City of Portland, Maine – Building or Use Permit Application 389 Congress Street, 04101, Tel: (207) 874-8703, FAX: 874-8716

DATE: 2 July 98 ADDRESS: 69 Lane Ave. 310-D-023
REASON FOR PERMIT: To Construct 24'x28' Detached private garage
BUILDING OWNER: Larry Bowie
CONTRACTOR: SAA
PERMIT APPLICANT: _____
USE GROUP U BOCA 1996 CONSTRUCTION TYPE 5B

CONCRETE SLAB LAYOUT

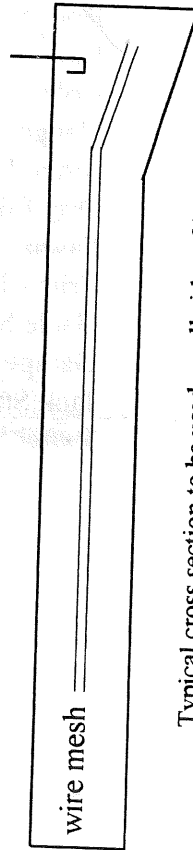
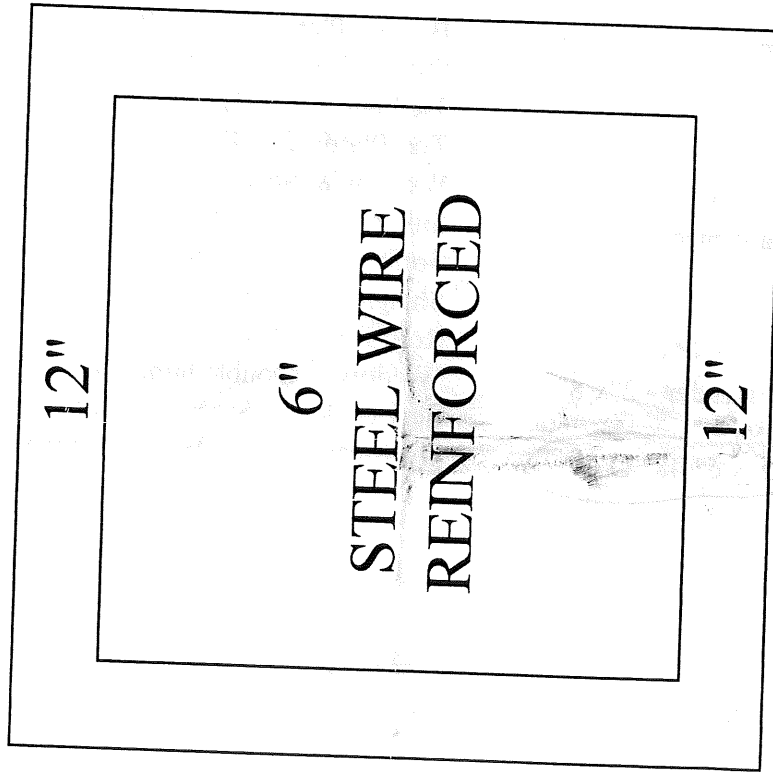
- ✓ Roof Sheathing - 1/2" plywood
- ✓ Rafters - 2"x 8" 16" O.C.
- Collar Tie - 2"x 4"
- Hanger - 2"x 4"
- Ridge Board - 2"x 6"
- Drip Edge Galvanized
- Fascia - Pine
- Trim - Pine
- Gable Studs - 2"x 4" 6
- Garage Door Header - 2"x 8"
- Jack Stud - 2"x 4"
- Rafter Tie - 2"x 6" 48" O.C.

- Bottom Plate - 2"x 4" Pressure Treated
- Studs - 2"x 4" 16" O.C. *change to 2x6 16 oc*
- Tie Plate - 2"x 4" 6
- Top Plate - 2"x 4" 6
- Window & Service Door Headers - 2"x 6"
- Siding - T-111 5/8"
- Soffit - AC 3/8" Pine
- Shingles - 20 year
- Roof Pitch - 5/12
- Windows - Double hung 24"x32" {optional}
- Service door - Steel insulated {optional} *36" x 80"*
- Overhead Doors - Wood or Steel, *36" x 80"*

CONCRETE SLAB LAYOUT

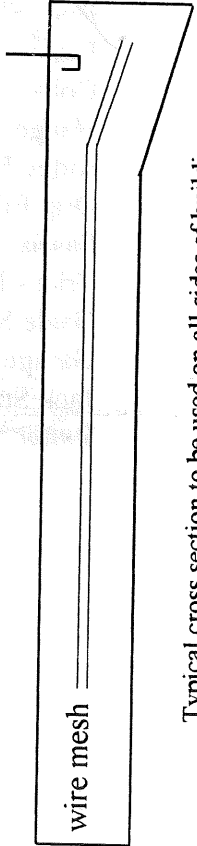
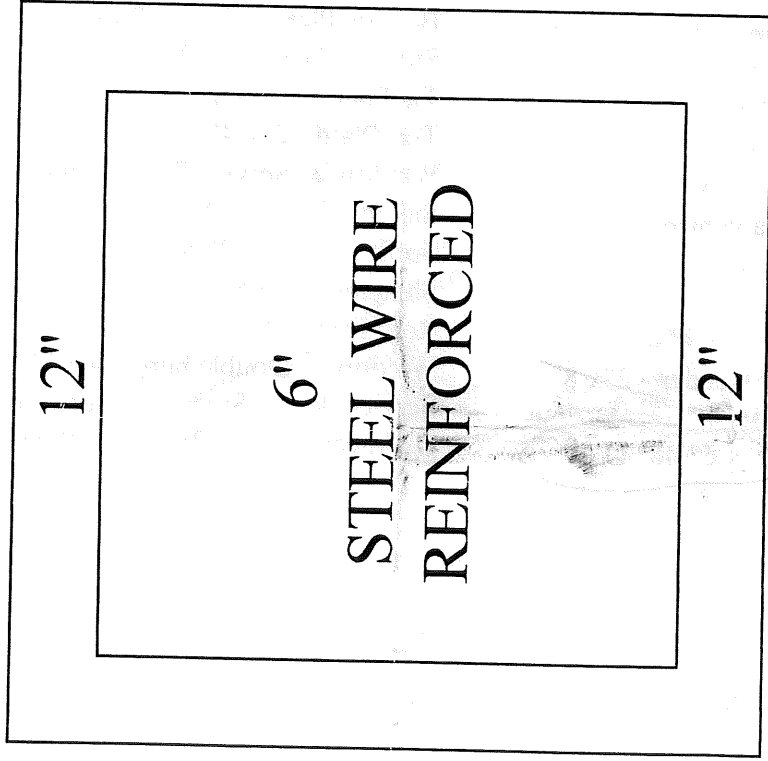
- ✓ Roof Sheathing - 1/2" plywood
- ✓ Rafters - 2"x 8" 16" O.C.
- Collar Tie - 2"x 4"
- Hanger - 2"x 4"
- Ridge Board - 2"x 6"
- Drip Edge Galvanized
- Fascia - Pine
- Trim - Pine
- Gable Studs - 2"x 4" 6
- Garage Door Header - 2"x 8"
- Jack Stud - 2"x 4"
- Rafter Tie - 2"x 6" 48" O.C.

- Bottom Plate - 2"x 4" Pressure Treated
- Studs - 2"x 4" 16" O.C. *change to 2x6 16 oc*
- Tie Plate - 2"x 4" 6
- Top Plate - 2"x 4" 6
- Window & Service Door Headers - 2"x 6"
- Siding - T-111 5/8"
- Soffit - AC 3/8" Pine
- Shingles - 20 year
- Roof Pitch - 5/12
- Windows - Double hung 24"x32" {optional}
- Service door - Steel insulated {optional} *36"x8"*
- Overhead Doors - Wood or Steel, *36"x8"*
